**Addendum No. 2**  
**November 27, 2024**

**Project: SIOUX FALLS CAREER & TECHNICAL EDUCATION ACADEMY'S AGRICULTURE  
& CARPENTRY ADDITION PROJECT PD #3471**

Architect: Architecture Incorporated

4.10A

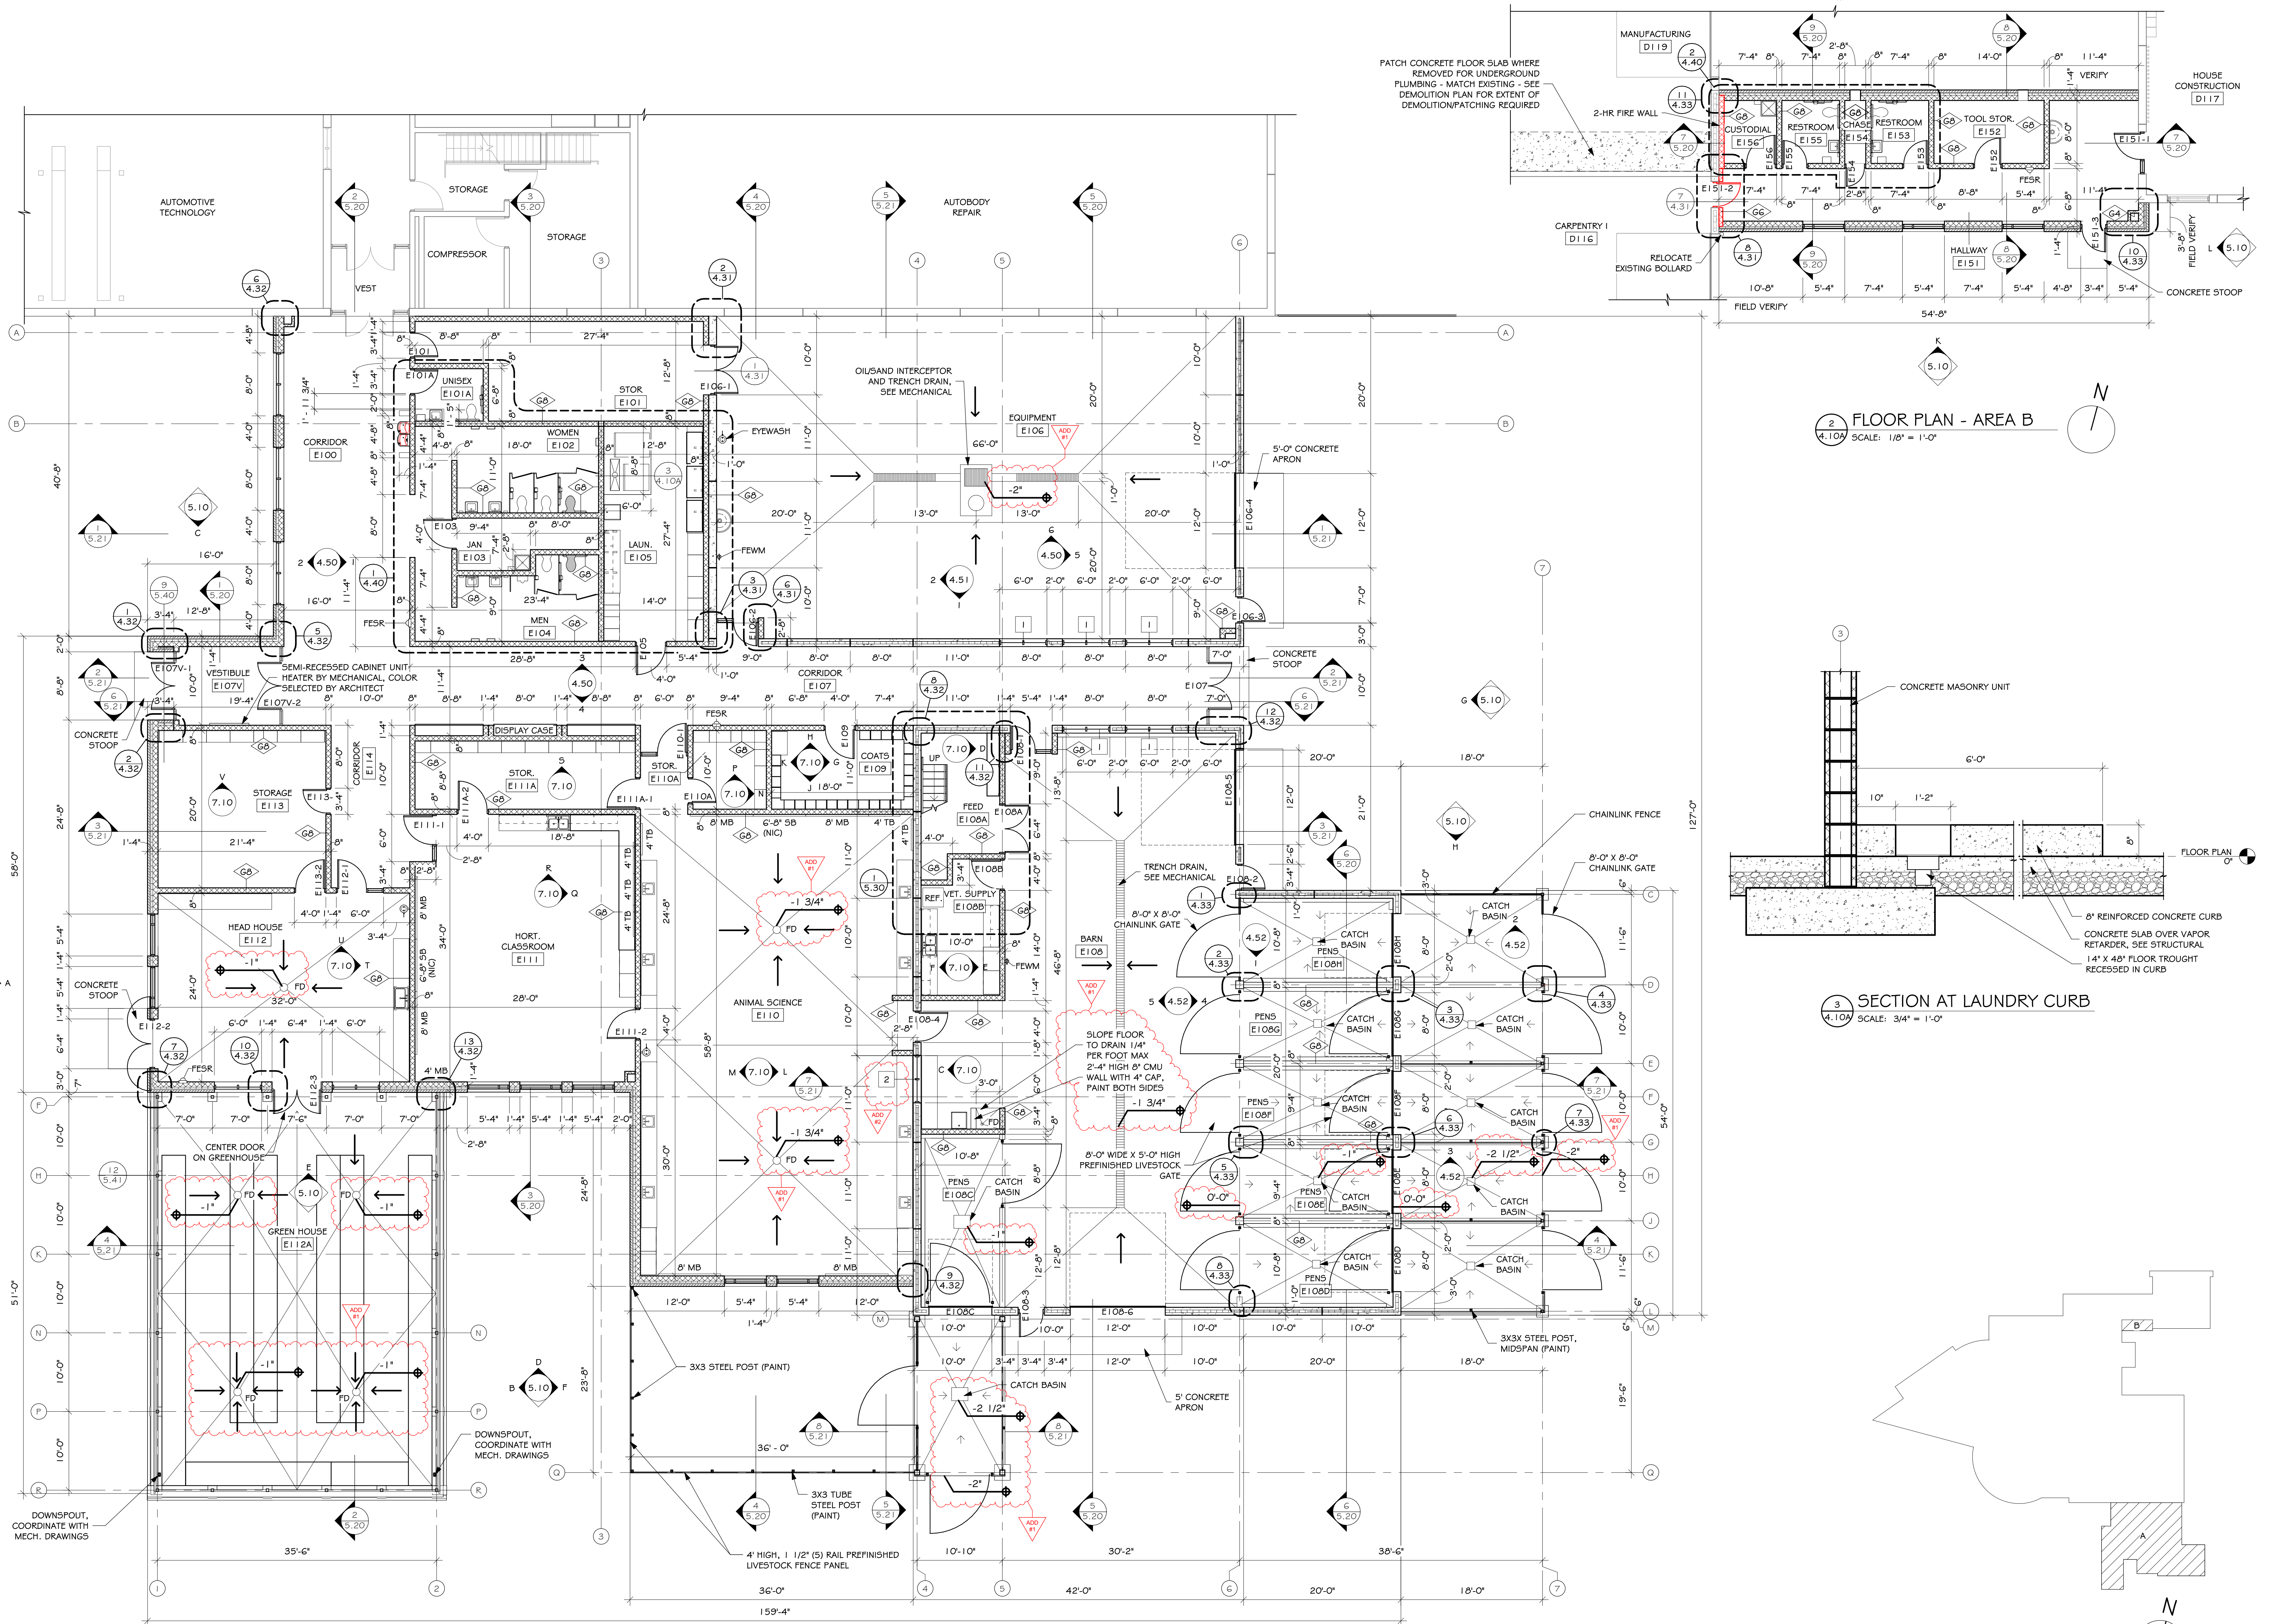
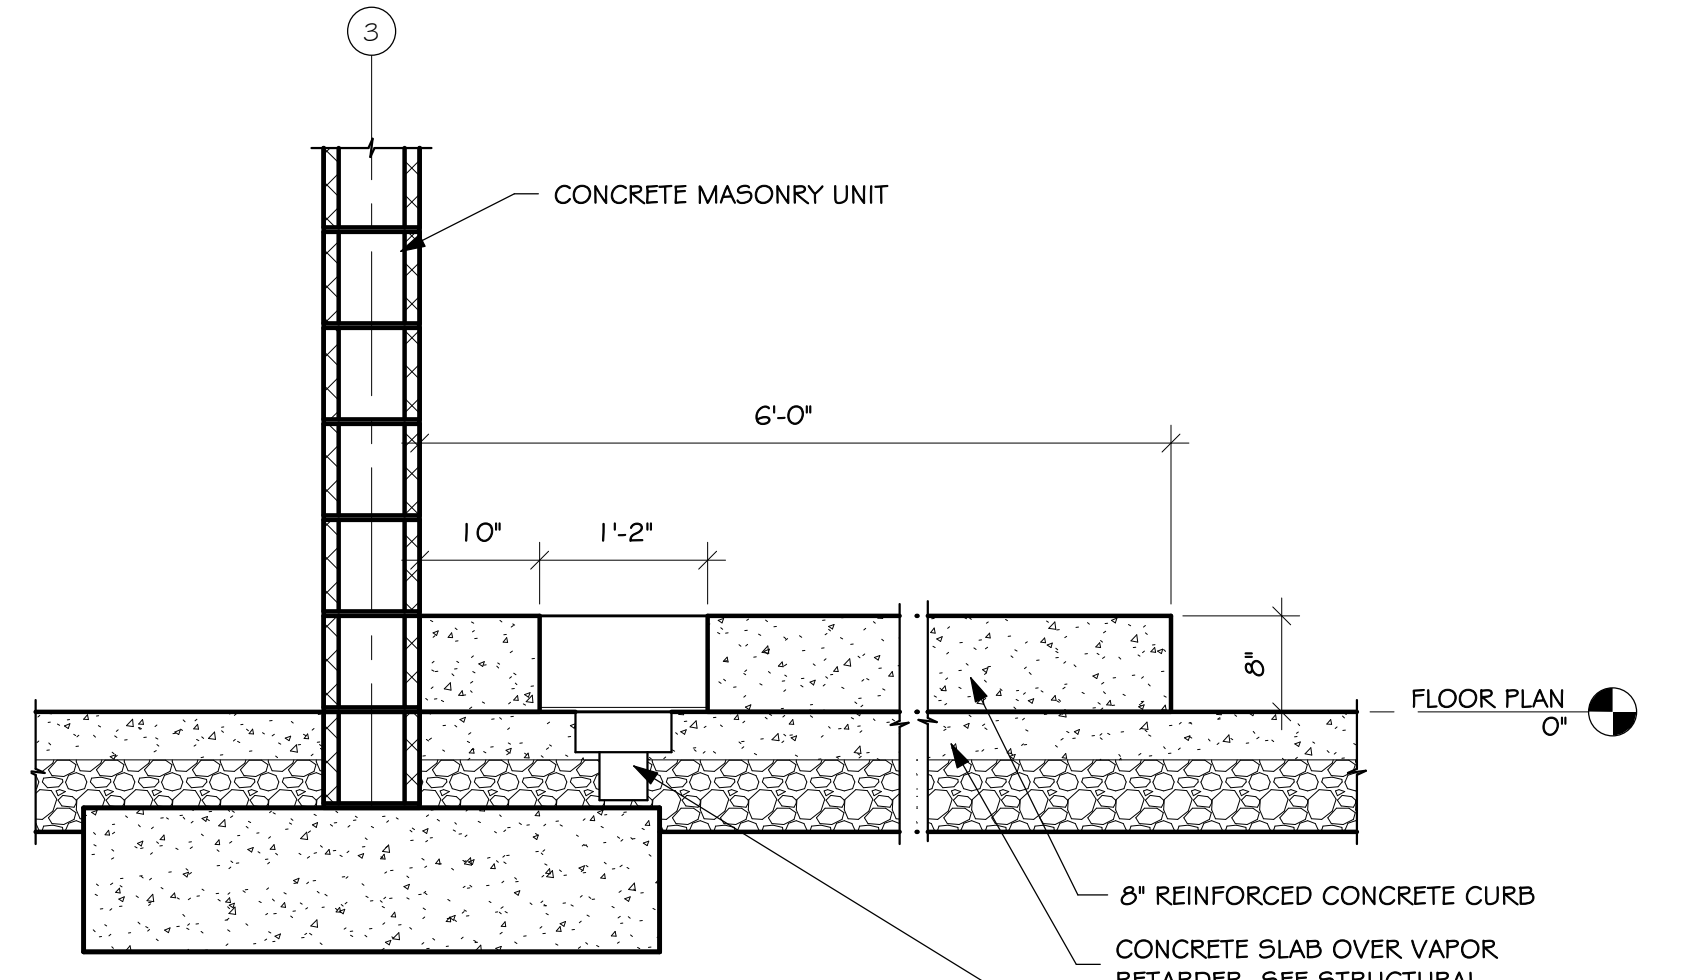
- a) The Type 1 borrowed lite that occurs in the precast wall between Barn E108 and Animal Science E100 (south of door E108-4) shall be changed to a Type 2 borrowed lite.
  - i) Reference *revised* drawing Sheet 4.31 attached to Addendum #2 for additional information.
- b) CLARIFICATION: The tables shown around the perimeter (and in the middle) of Green House E112A shall not be included in the Contractor’s Base Bid. These items will be Owner-furnished / Owner-installed.
- c) CLARIFICATION: All livestock gates shall be 4’-4” high as specified per Section 323116.
  - i) The keynote north of overhead door opening E108-6 which reads 8’-0” WIDE X 5’-0” HIGH *PREFINISHED LIVESTOCK GATE* shall be changed to read:

***8’-0” WIDE X 4’-4” HIGH PREFINISHED LIVESTOCK GATE***

- d) The Contractor shall include furnishing and installing a 1.5” OD single steel pipe detectable cane rail beneath the stair stringer in Feed E108A. Length: 7’-6”. Height: 24” A.F.F. to top of pipe. Assembly to be bolted to floor.
- e) Reference (attached) *supplemental* drawing SD-1, dated 11-27-24, attached to the end of this addendum for additional information / details for the oil/sand interceptor in Equipment E106. Oil/sand interceptor to be furnished and installed by the General Contractor.
  - i) The interceptor may be cast-in-place or precast – Contractor’s option.
  - ii) Acceptable Precaster: Josten Concrete Product Company, Inc (Sioux Falls, SD).
